4.3 Jones Bay Road F&B Tenancy

4.4 Revised Ritz Carlton to Star Resort links

4.5 Car Stacker

Revised AF3000 L00 FFE Ground Floor Plan

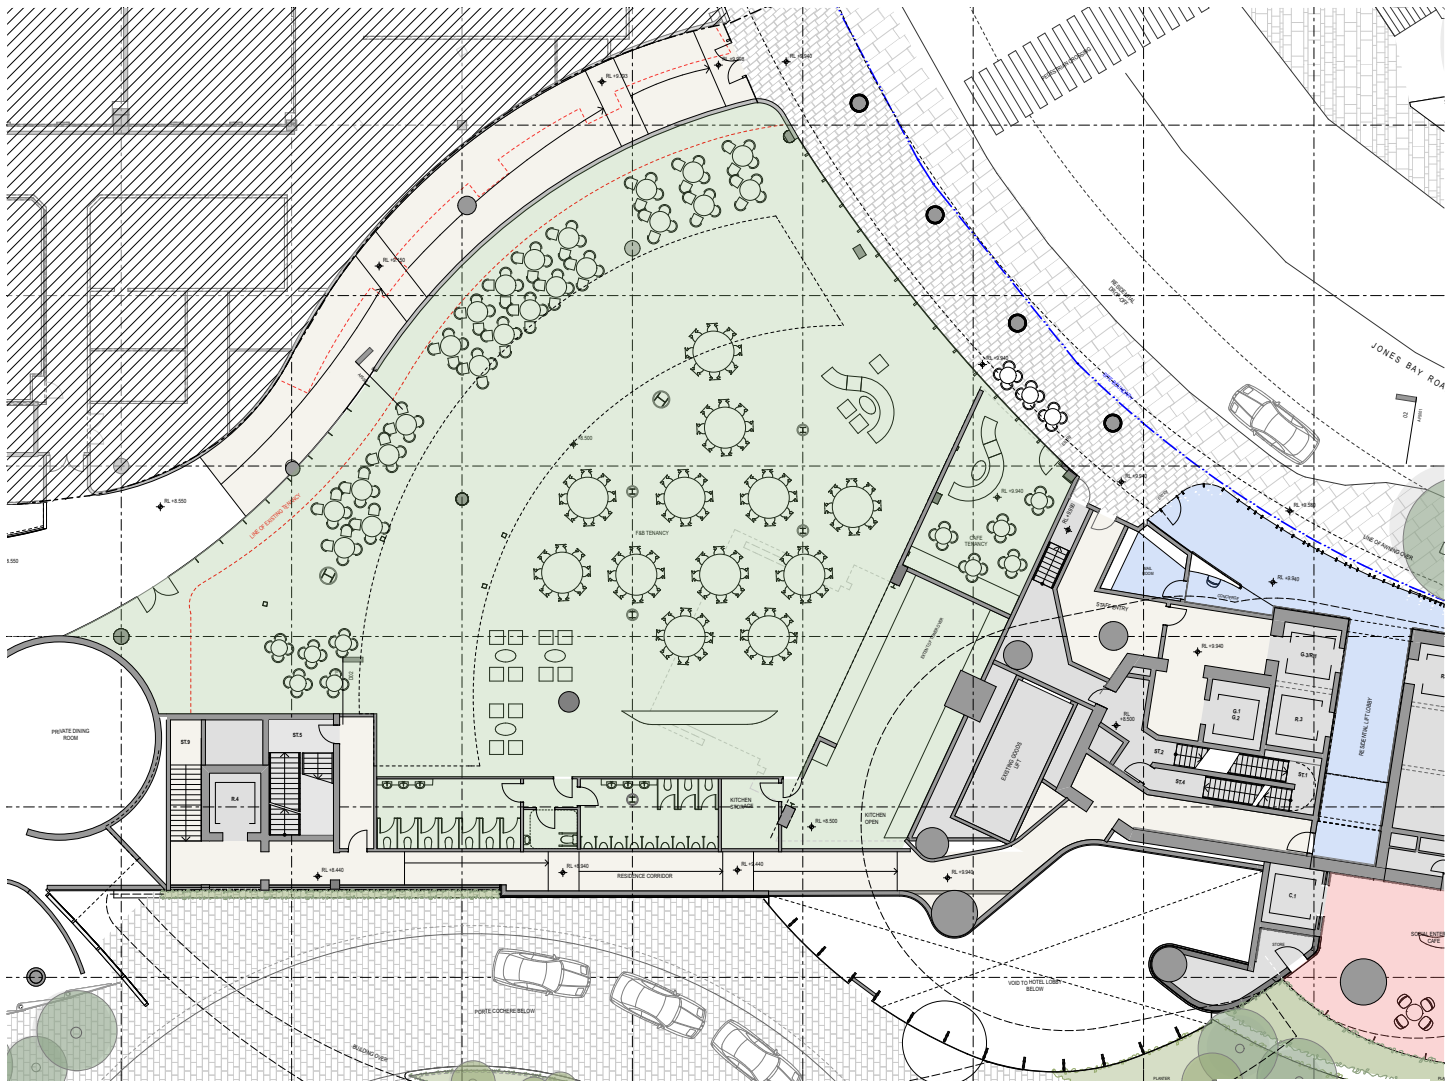
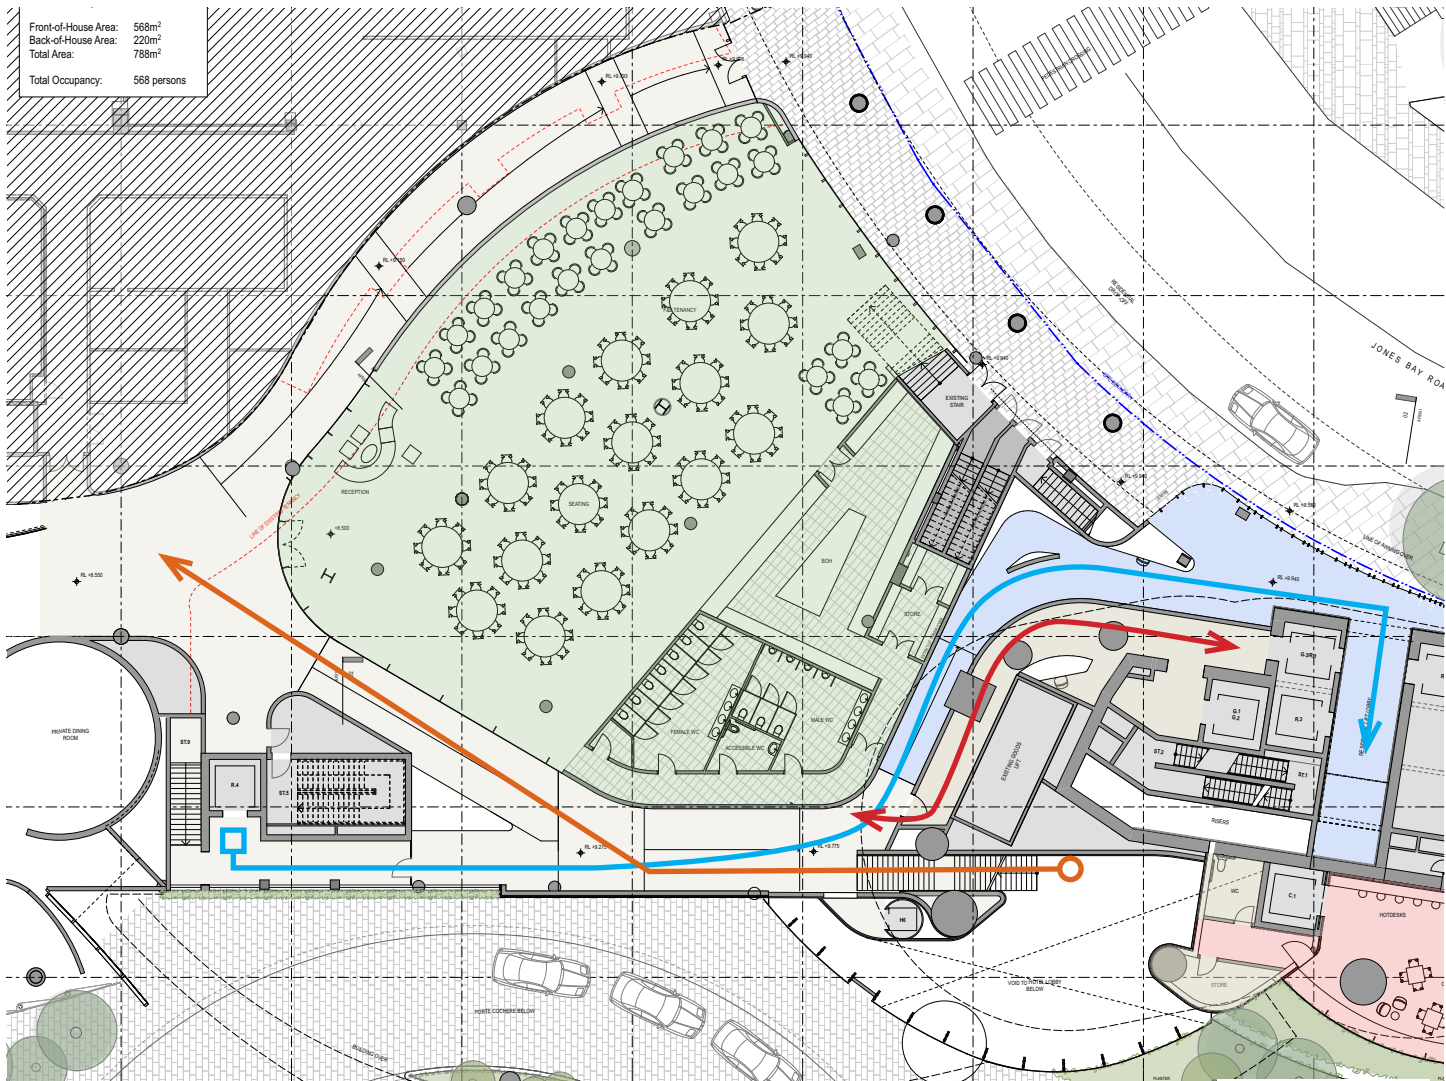
Personal submissions received posed questions regarding the two L00 F&B tenancies to Jones Bay Road. These questions related to several topics, including acoustic conditions, trading hours, operability of the facade and external seating along the colonnade.

New Restaurant and Retail spaces on Jones Bay Road are missing access points / wall openings / door & glazing details an architectural and design level submission to NSW Planning & Environment and City of Sydney Council level.... Following the basis of current proponents restaurant /retail tenants closing business 11pm - Mon,Tue, Wed, Thur . Midnight - Fri & Sat and 10pm on Sundays. This missing architectural and design detail directly relates to noise pollution / people congregating on Jones Bay Road which will negatively impact sensitive respondents / us living in our home.

In response to these concerns regarding operations and acoustics the following strategies have been implemented since formal lodgement.

- Changes to internal planning and arrangement due to revised Hotel to Star Resort link and reconfigured residential and staff access
- External tenancy seating has been removed
- The Cafe tenancy has been removed due to design development of the residential lobby and egress stairs
- There is to be no facade openings from Jones Bay road colonnade into the F&B tenancy
- Noise emission will be controlled to meet the noise emission criteria set out in the WSP acoustic report throughout detailed design phases.

Revised AF3000 L00 FFE Ground Floor Plan

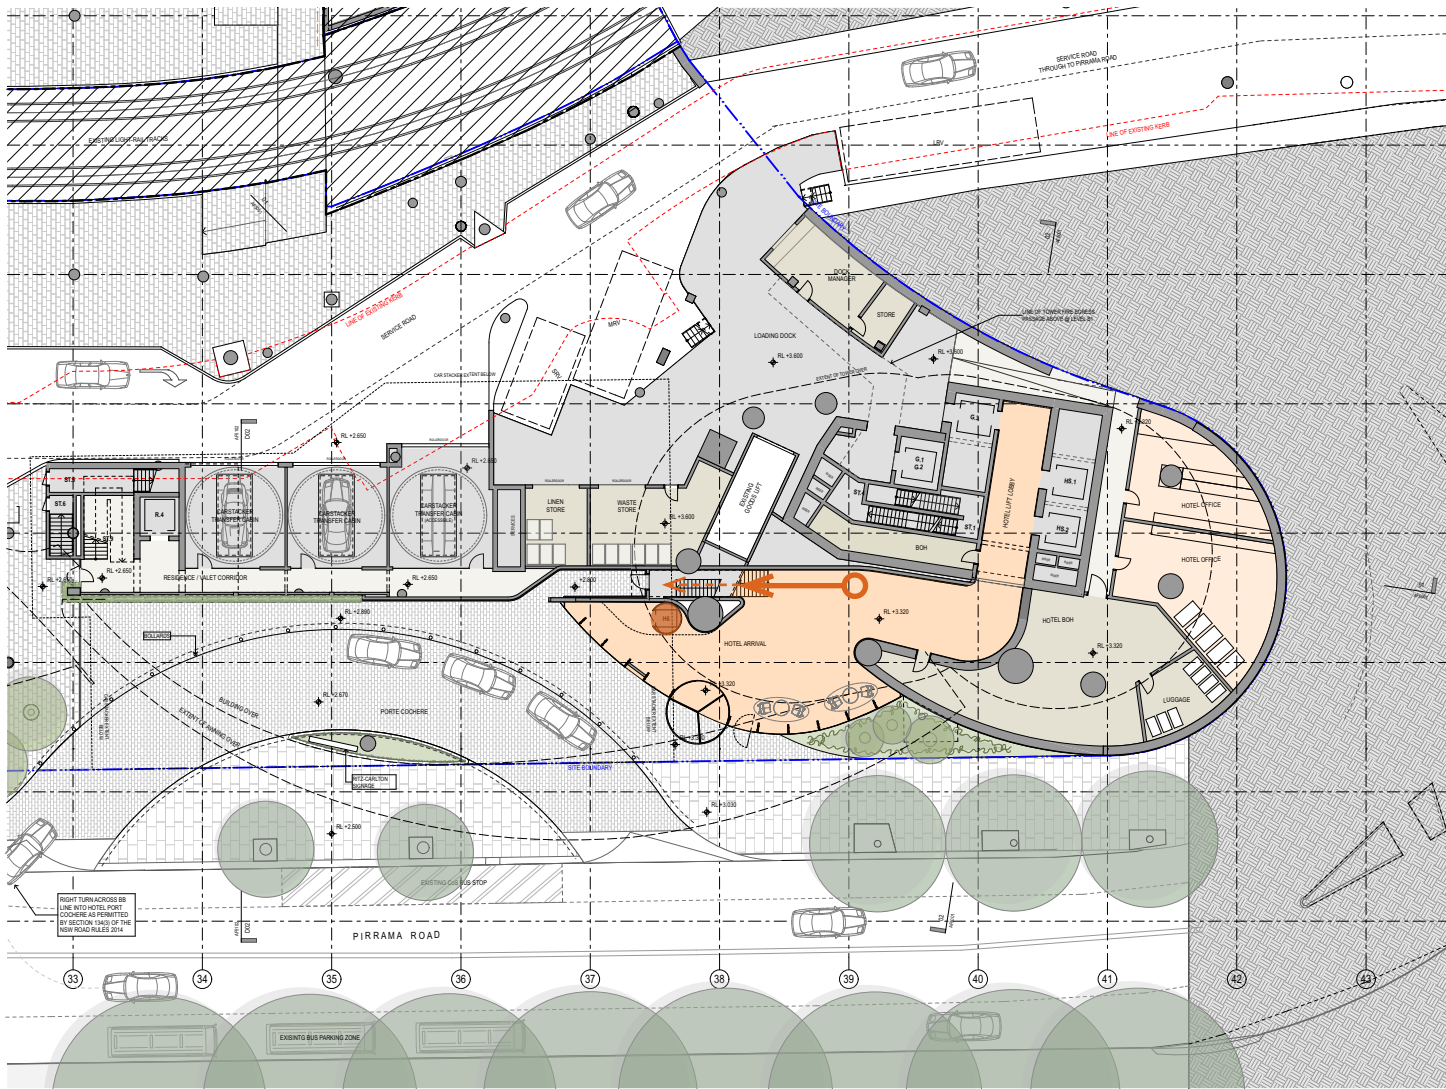
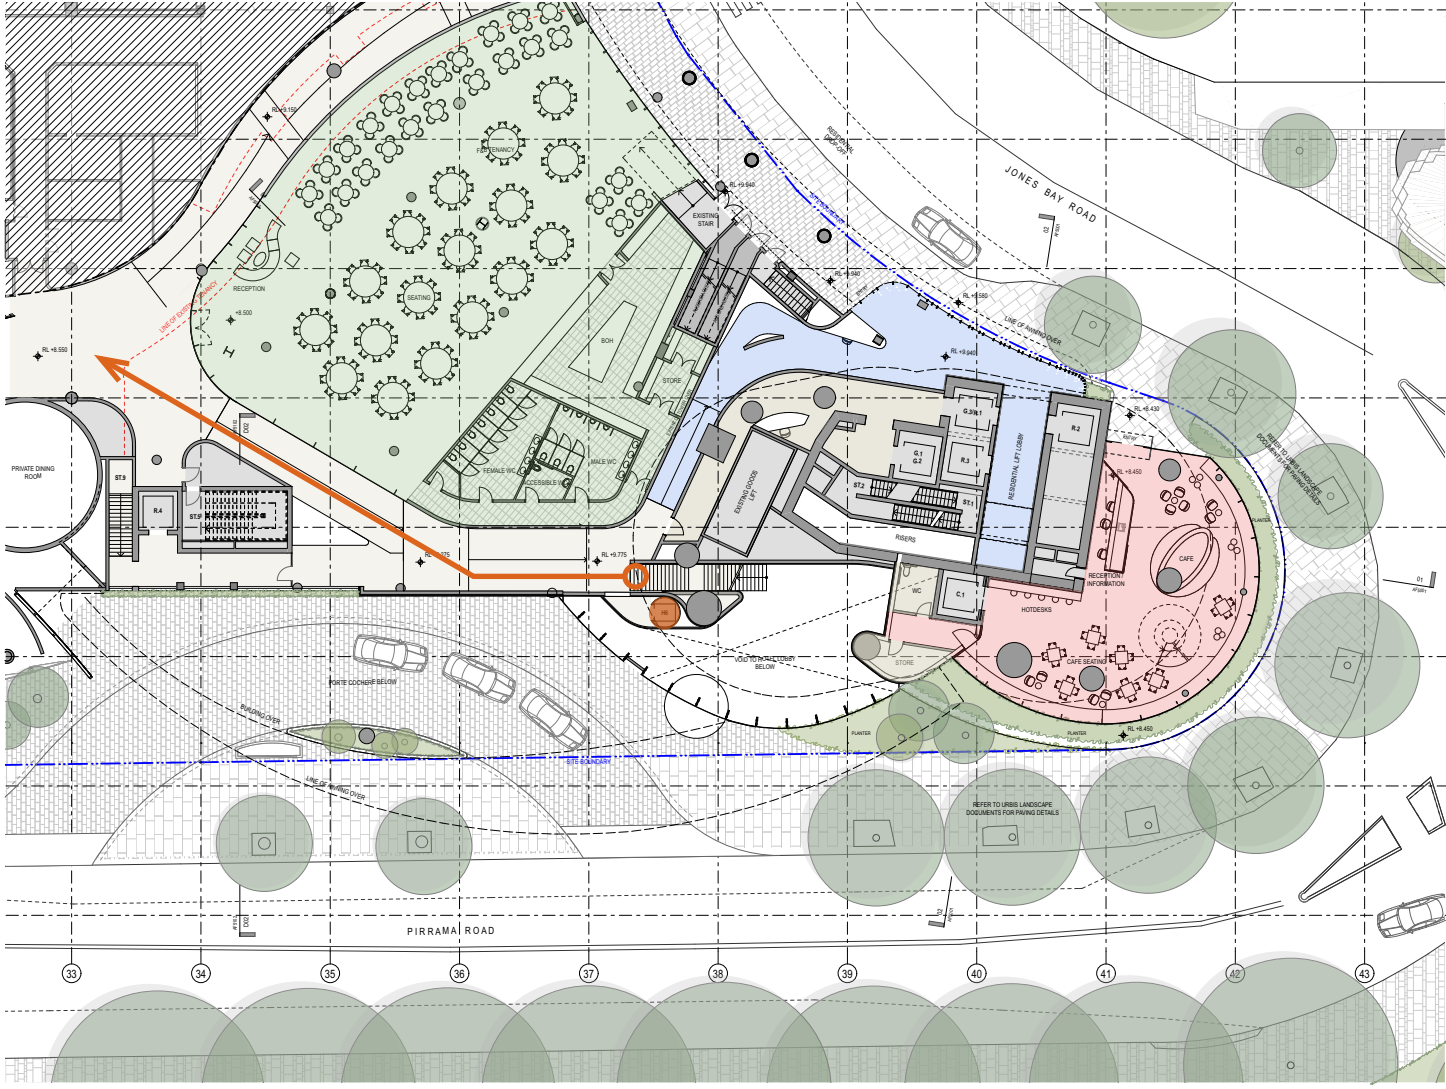
Hotel Lobby to L00 link (New)

Through removal of legacy structure at L00 and sloping show theatre slab under the Sports Bar a new link has been created from the Ritz Carlton Lobby on LB2 to L00 Restaurant Street. Hotel guest and visitors will now be able to move from the lobby fronting Pirrama Road up a grand staircase or DDA compliant lift to the L00 circulation network and into the wider Star resort.

The creation of this important link has resulted in redundancy of two VIP links proposed at formal lodgement.

Revised AF2004 L04 Mezz Floor Plan

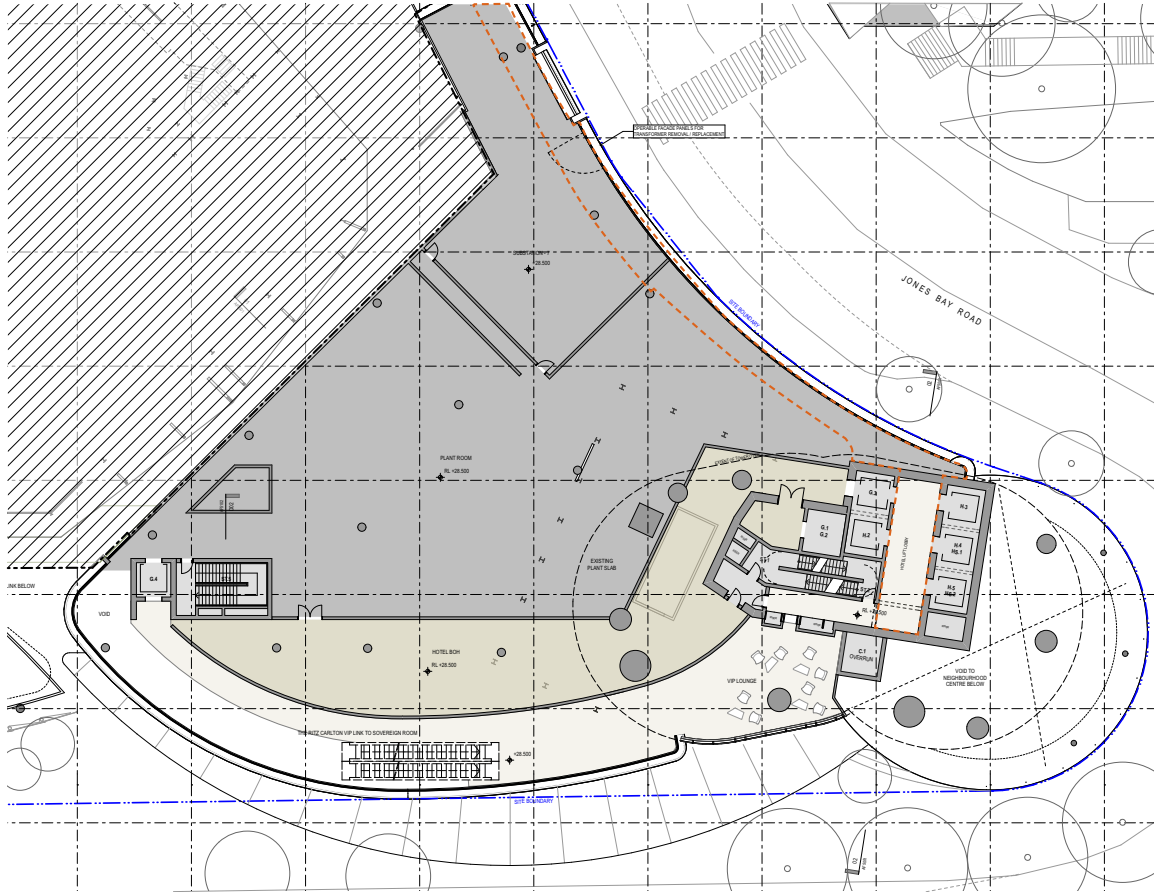
Jones Bay Road VIP link - L04 Mezz
(Removed)

Proposed as a VIP access from the Hotel tower core at L04 mezzanine, this link snaked along the Jones Bay Road facade as a new glass insertion. Length of travel, complications with fire rating and materials, plant room configuration at L04 and the creation of the Ritz Carlton lobby to L00 access has contributed to a reduced viability for this VIP path.

Revised AF4102 Jones Bay Road Elevation

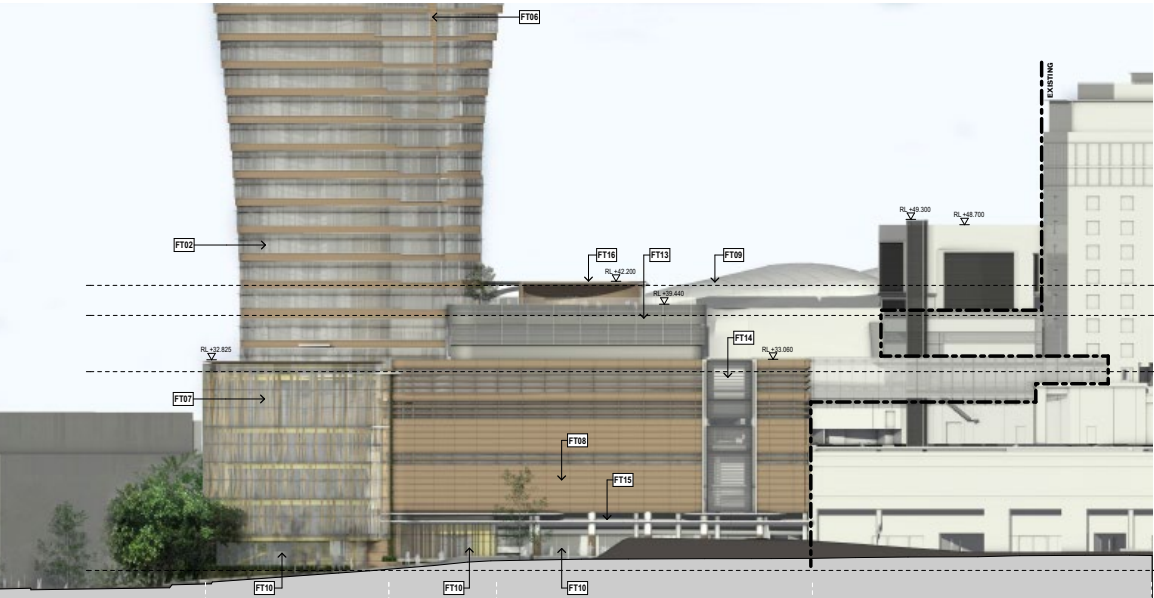
An elevation comparison of Jones Bay Road is shown (right). The revised elevation shows the removal of the glass link, and improved condition for neighbouring residents along Jones Bay Road.
